INFORMATION REQUEST RESPONSE
NOISE IMPACT ASSESSMENT
PROPOSED CHILDCARE CENTRE
2-6 LANCEWOOD STREET
PARK RIDGE

MCUI/56/2023

Title: Information Request - Noise Impact Assessment – Proposed
Childcare Centre – 2-6 Lancewood Street, Park Ridge

The information request was issued on 2 November 2023 (Ref: 17088124) with Items 4.9 to 4.12 relating to acoustic matters as follows:

Recorded Statistical Noise Levels for Park-Ridge 23091 - - 18-Jul-2023 - Tuesday

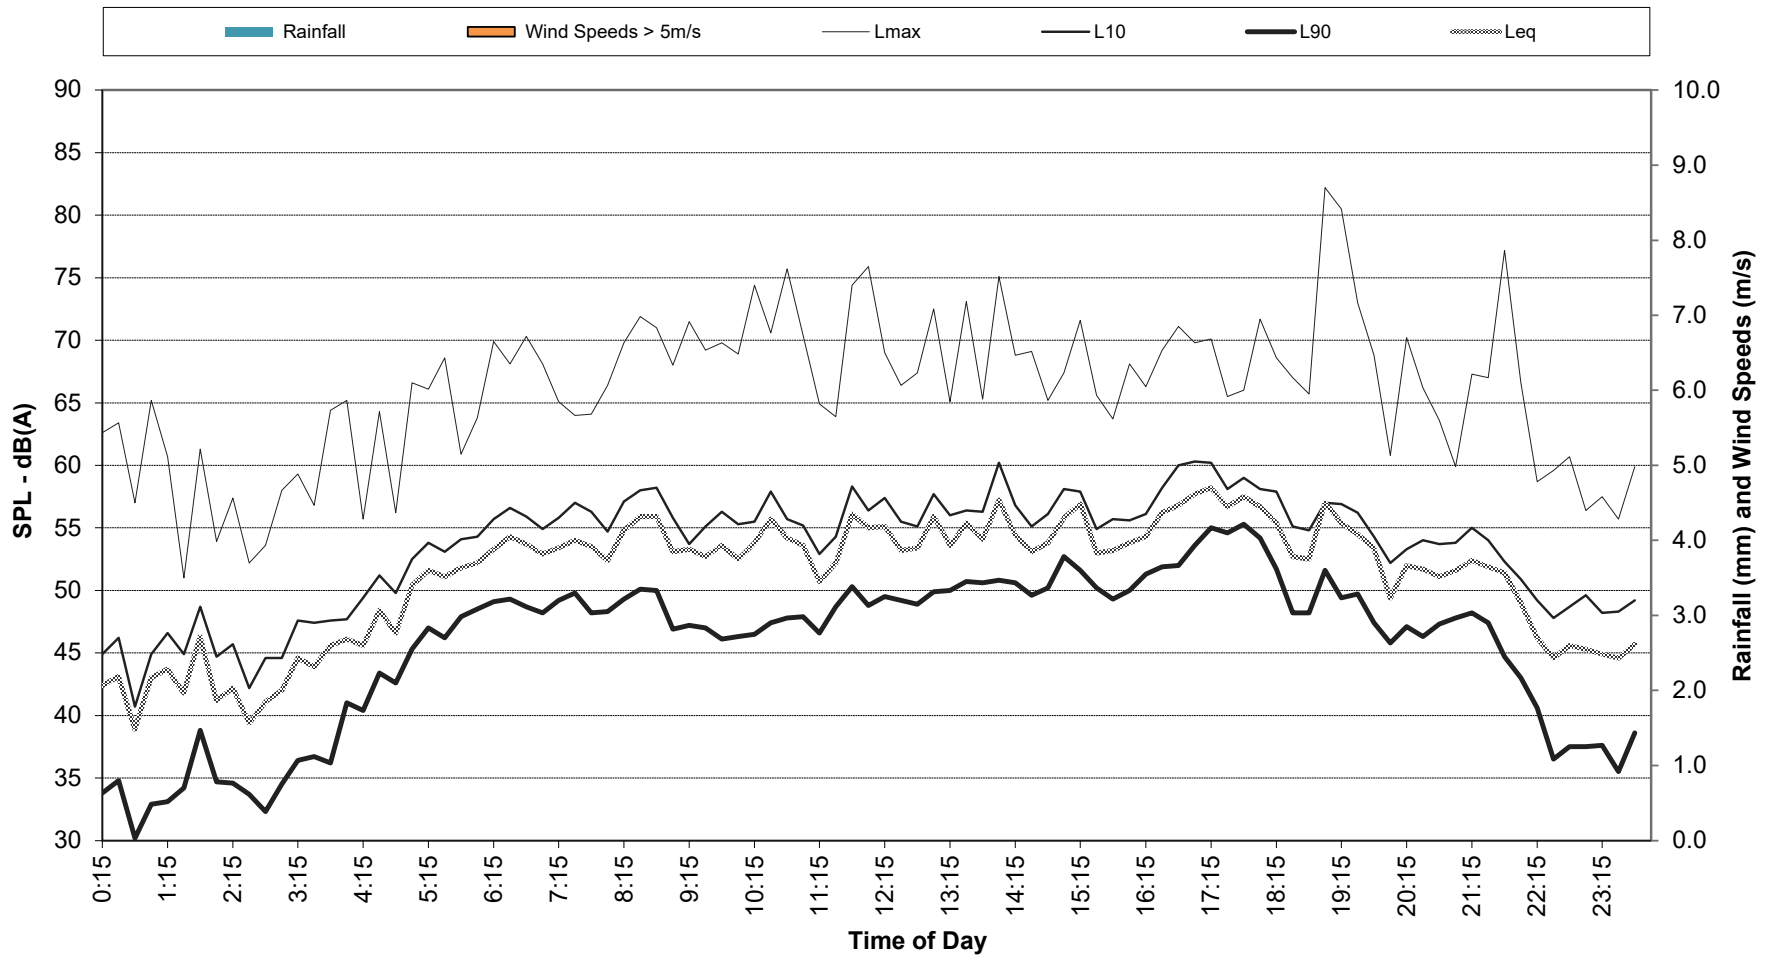
Confirm that all the noise data affected by inclement weather have been removed in the calculation of background noise levels.

BOM website indicates that rainfall was recorded at Logan City and Greenbank (Defence) weather stations on 18th and 19th July 2023.

Review of the recorded rainfall from the Bureau of Meteorology for both weather stations at Logan City and Greenbank indicated that maximum of 3.4mm rainfall occurred on the 18th July and 0.2 to 0.4mm rainfall occurred on the 19th July.

The analysed noise data for the 18th July provided no indication that the recorded noise data was impacted by rainfall, however for this updated noise impact assessment, the noise data from the 18th July has been removed from the assessment.

When removing the noise data from the 18th July, there was no change to the assessed noise level and the relevant adopted criteria.
